**Our ref: PR141576**

Date: 25 January 2022

## **Update to the Excavation Methodology at the Liverpool Health and Academic Precinct (LHAP) (SSD 10389)**

**Figure 1 - Location of the TPZ and TP locations within Area 1. Note, TP5 was relocated to be outside the TPZ. The blue line is the approximate edge of the concrete roadway.**

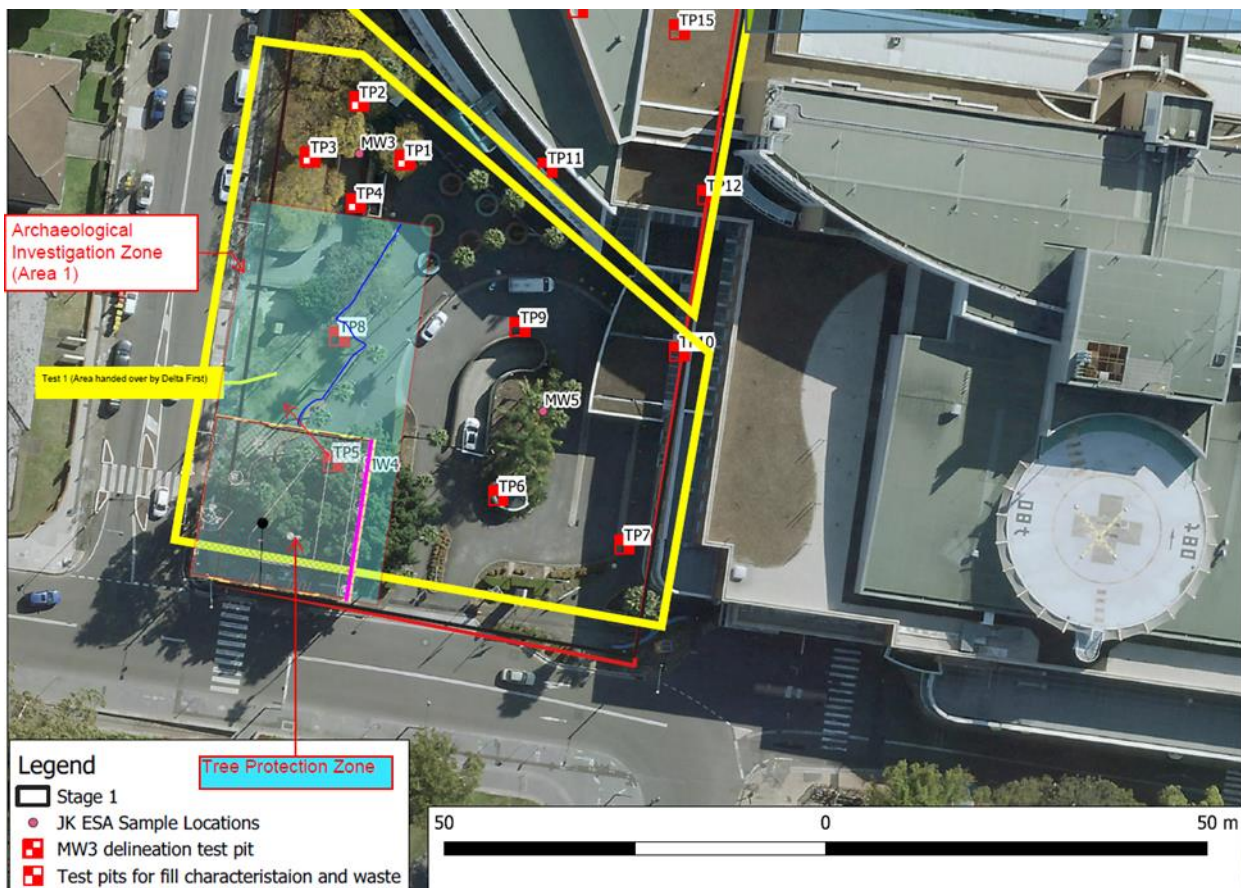
be dug within the TPZ but was relocated to the northwest as no excavation was allowed with the zone. The approximate locations of these test pits are in **Error! Reference source not found.** This work also enabled a sample to be documented on the soil profile of relevance to the archaeological assessment of Area 1.

Based on the results of these two test pits, re-examination of the area, and the maximum depth of excavation being 0.5m below the surface RPS no longer recommends a program of archaeological testing and instead suggests that monitoring is an appropriate methodology for Area 1 of the site.

Given the evidence seen in these two test pits RPS does not plan to undertake any other excavations or testing in the area. Machine excavation and the removal of the concrete slab will be monitored by a suitably qualified and experienced historical archaeologist.
